CHANGE ORDER 264  
INSTRUCTION BULLETIN  
DEFERRED APPROVAL  
ADDENDUM

PROJECT NAME  
**CHILDREN'S HOSPITAL  
OF ORANGE COUNTY**  
455 S. Main St.  
Orange, CA 92668-3874

TOWER II

A3.5G

B6 AREA G  
1/4" = 1' - 0"

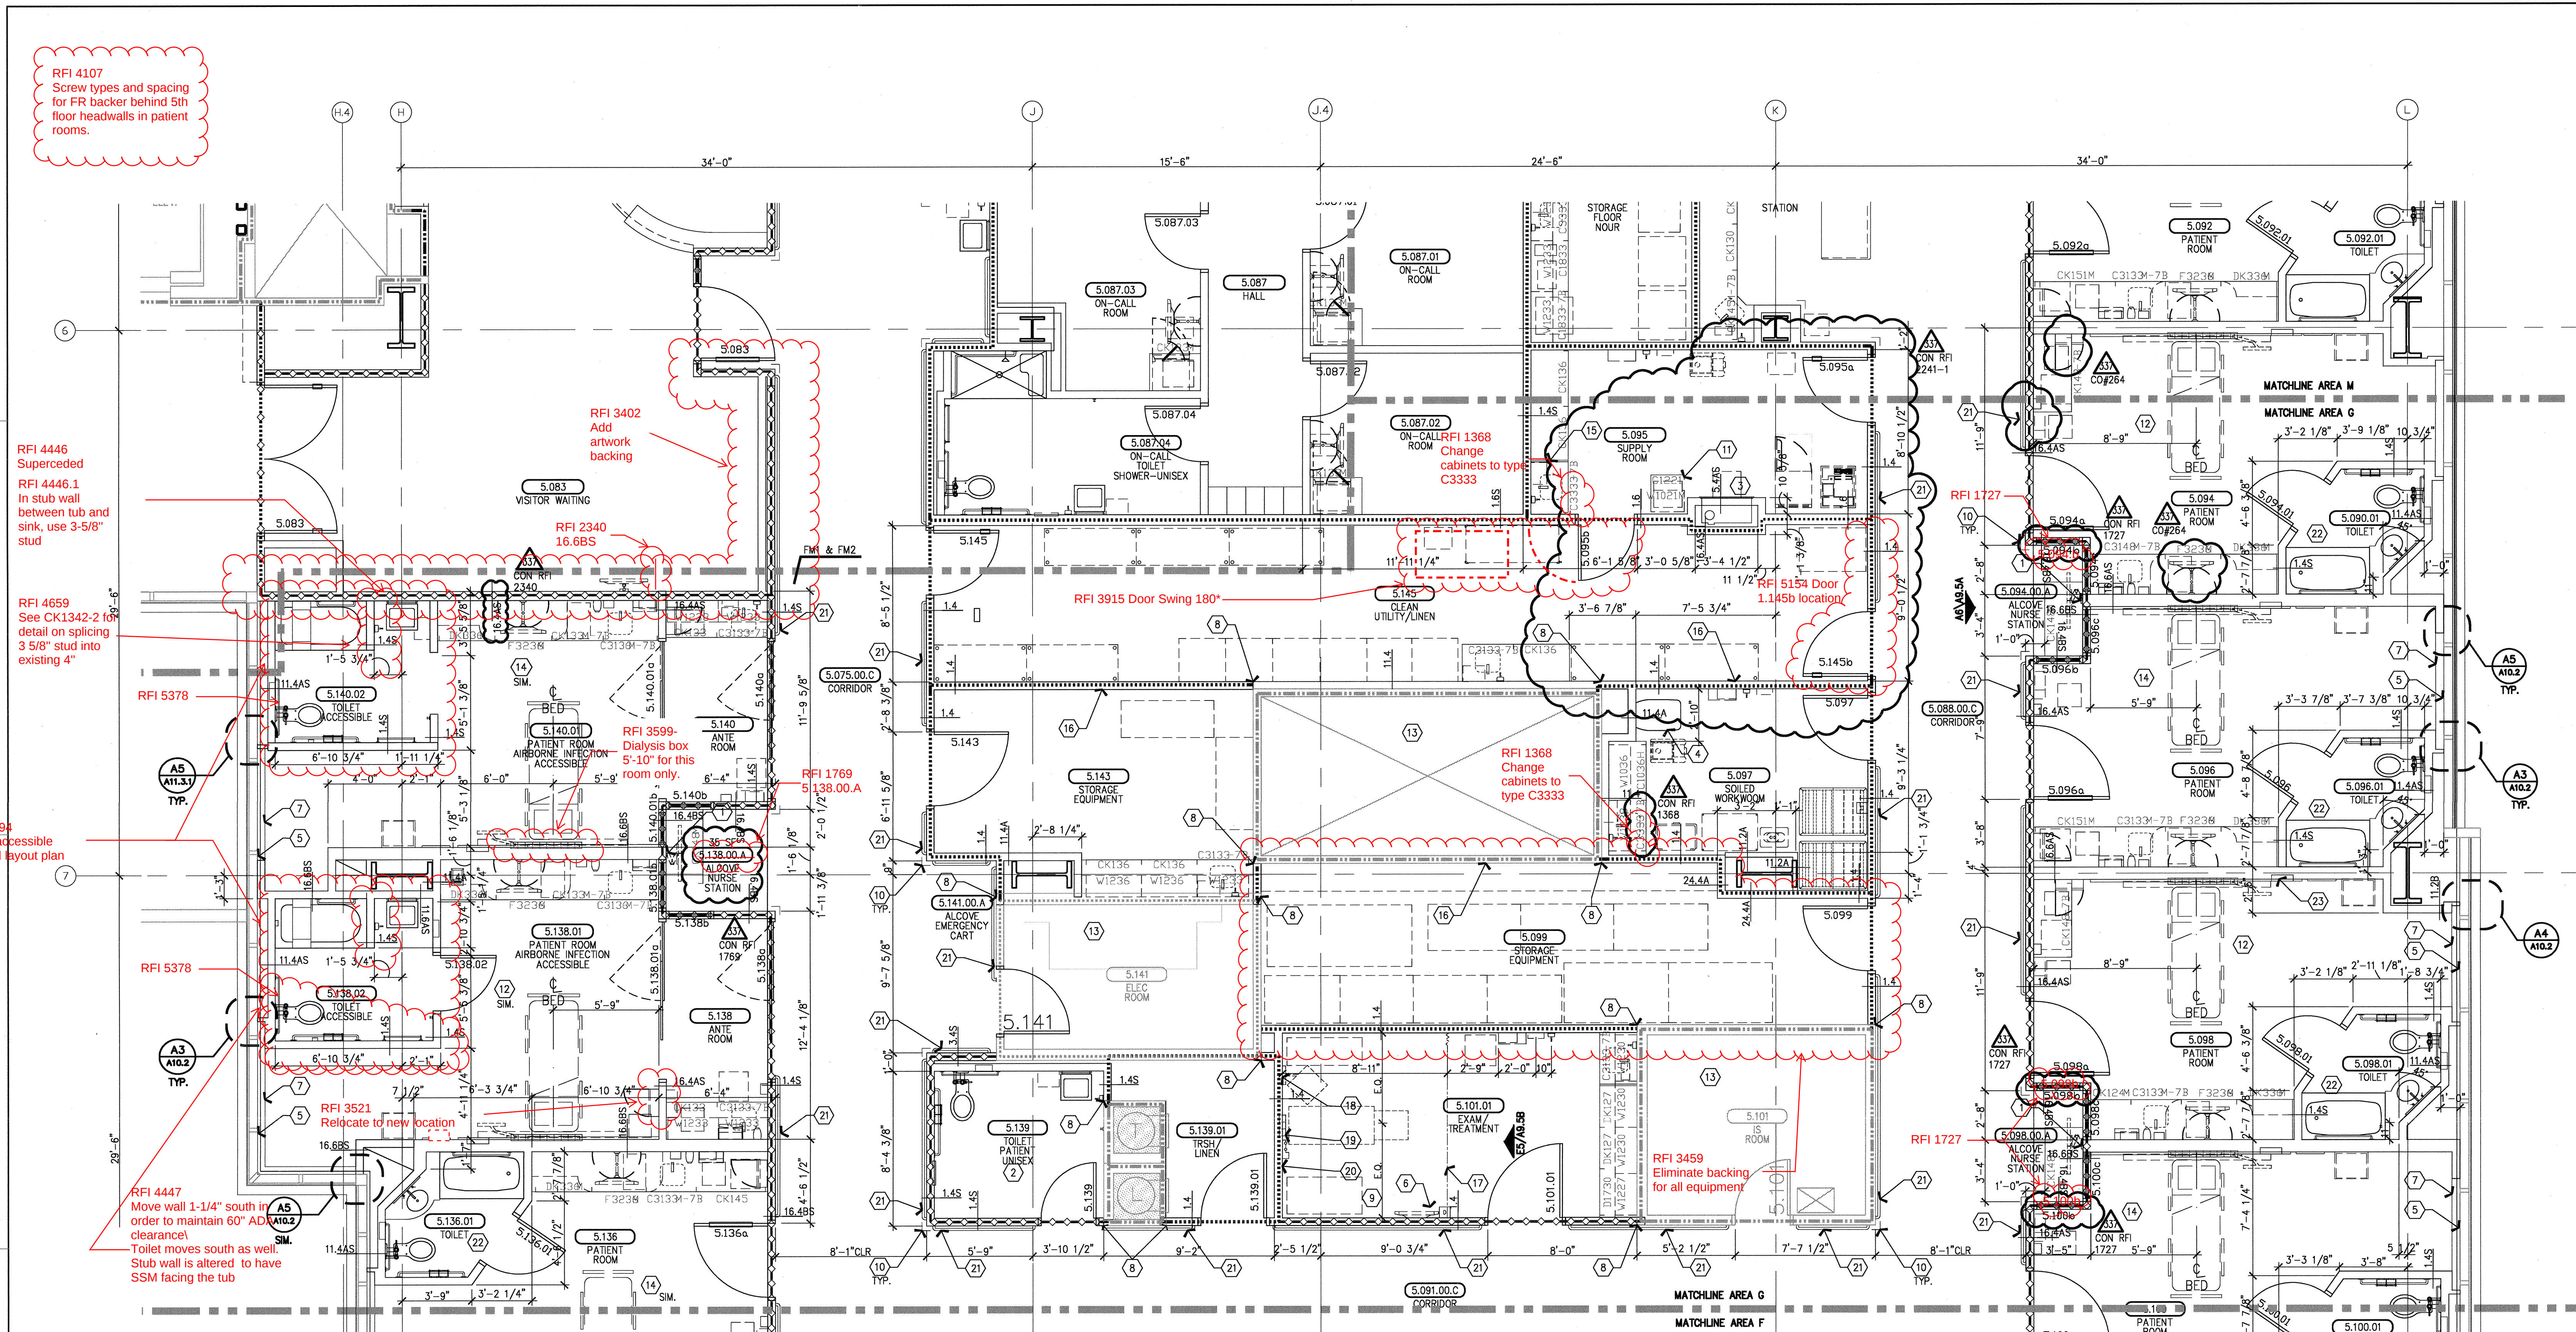
RFI 2324  
Panels shall be 1'-3" AFF and 14"x14"

Note: RFI 318 changed WC-4 to WC-3 at non-ADA toilets. Locate WC-3 15" from wall.
